Final Drainage Report  
for  
**Rolling Hills Ranch North Filing 1**  
at  
**Meridian Ranch**

April 2024

PCD Project No. SF-XXXX

**FIGURE 8**

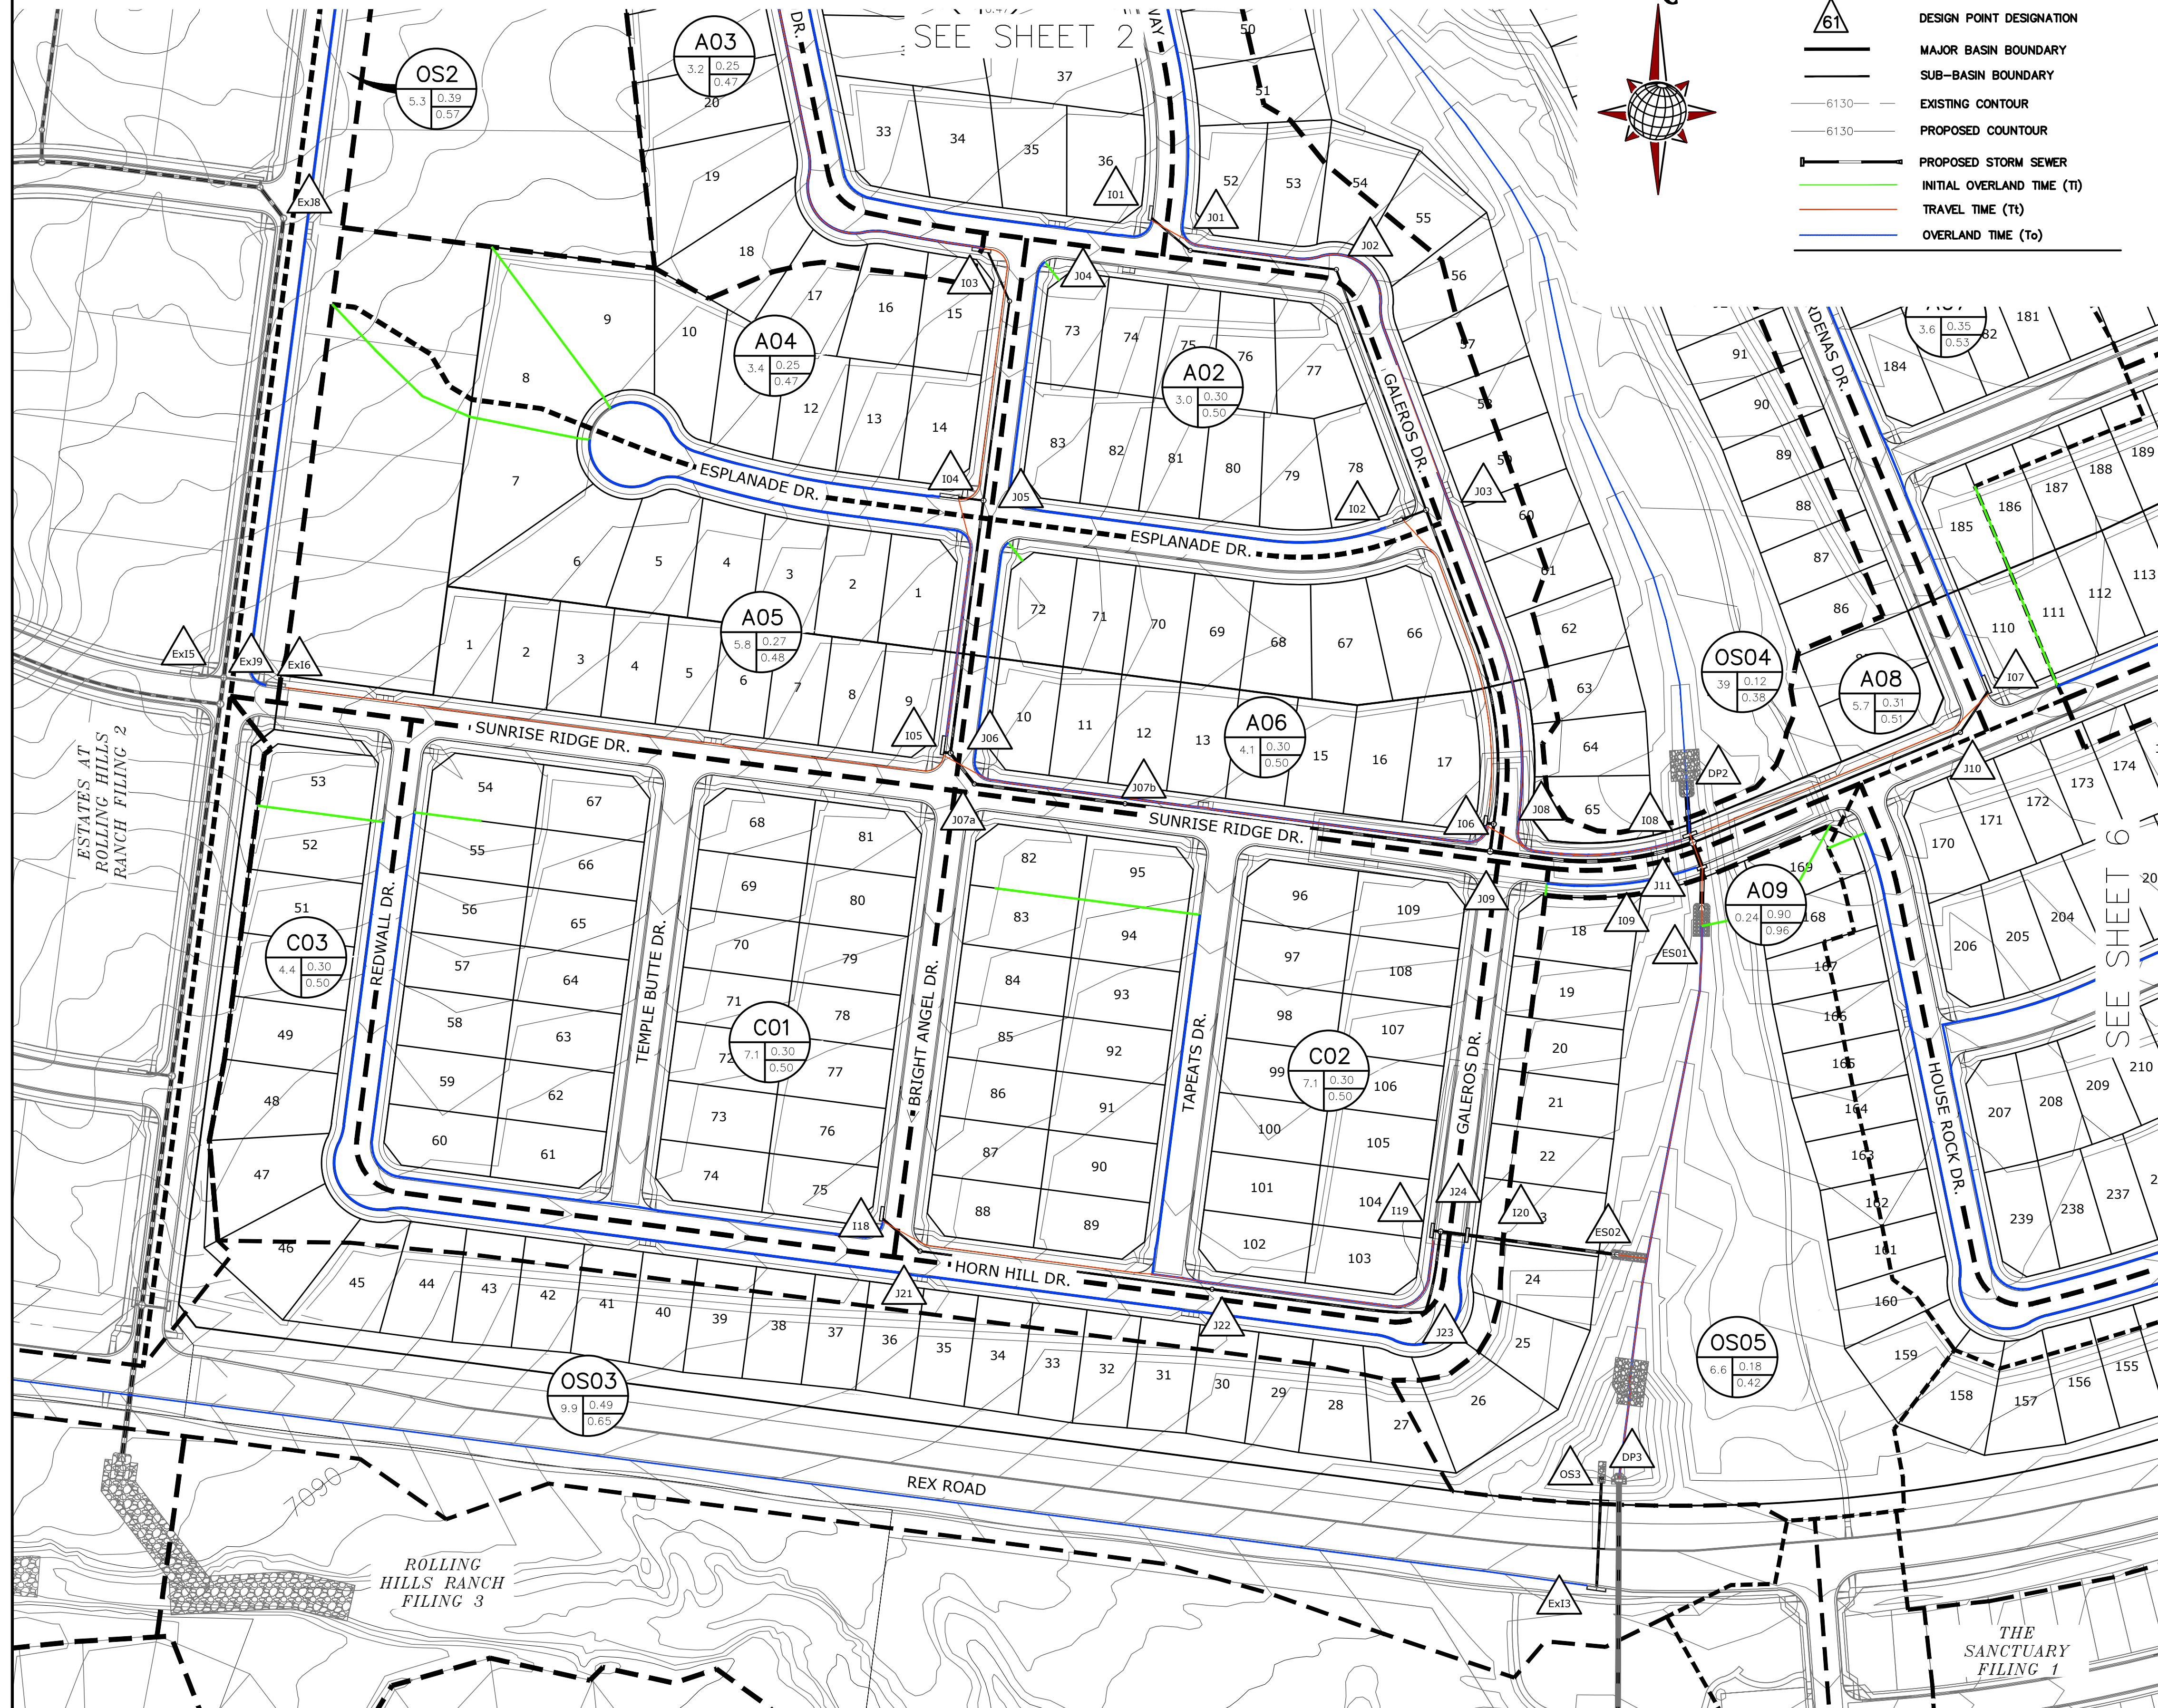
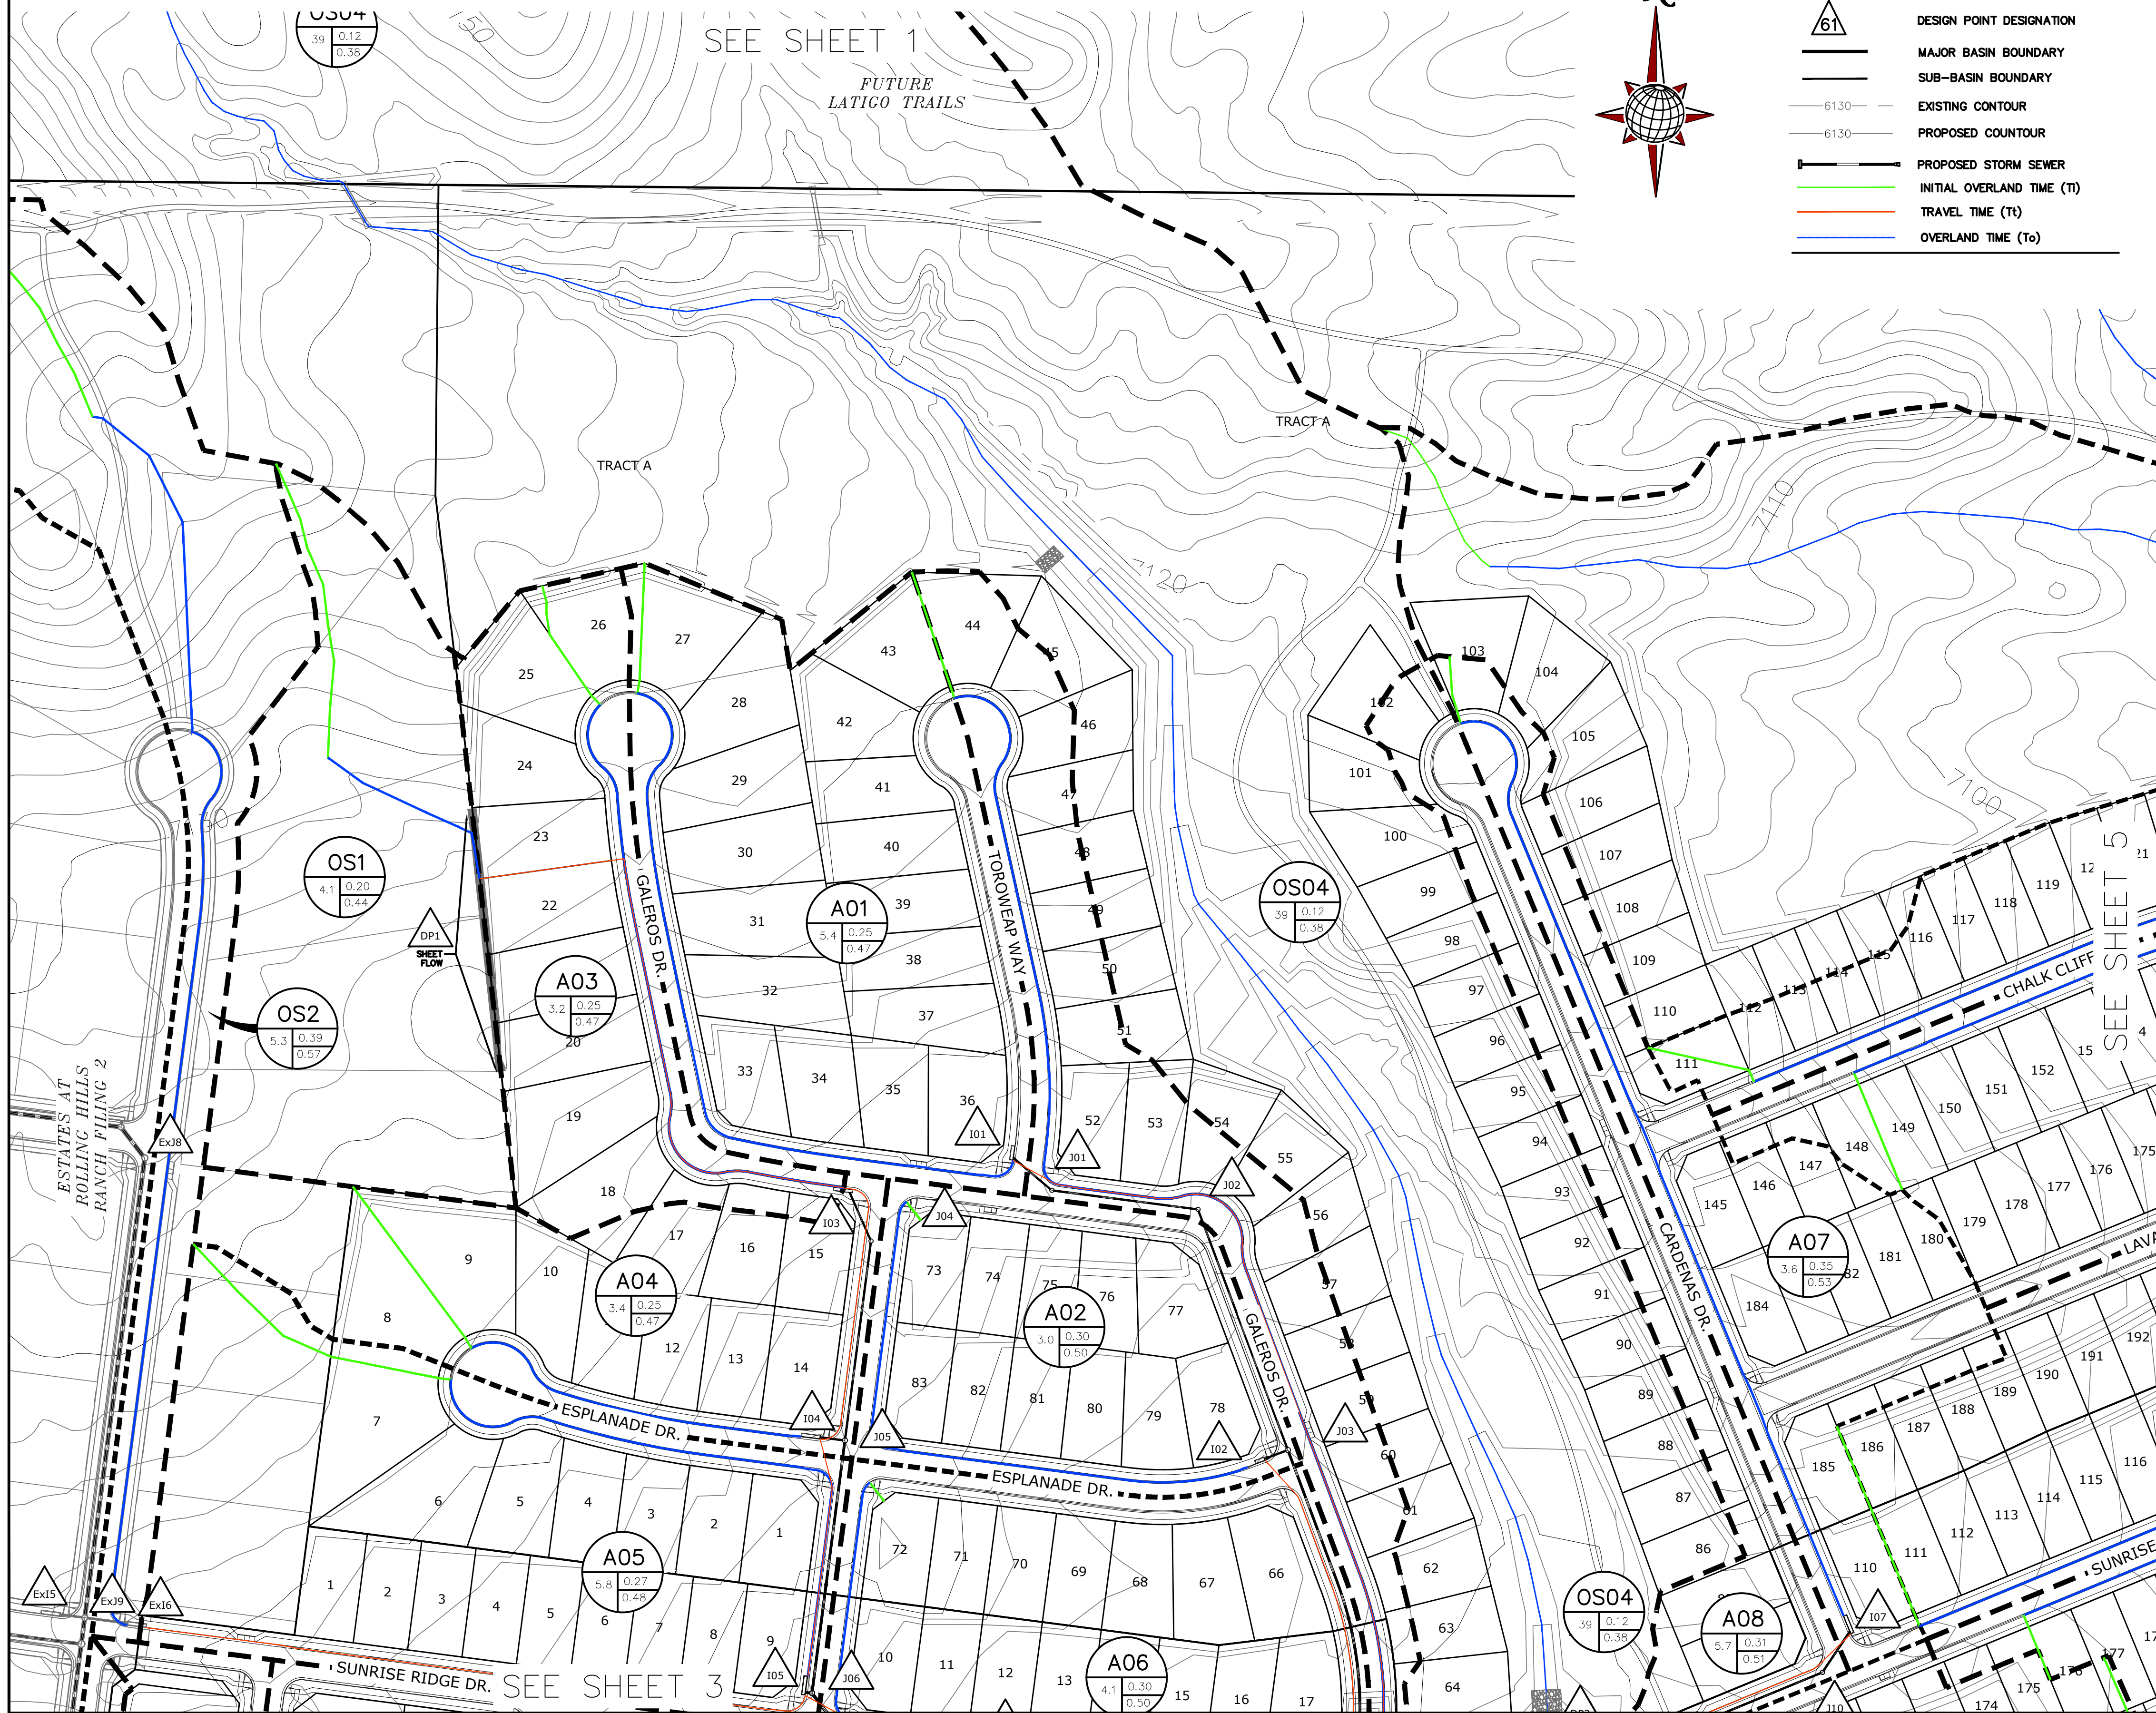
Figure 8 is not a water quality map and is not located in Appendix G, please include water quality map.
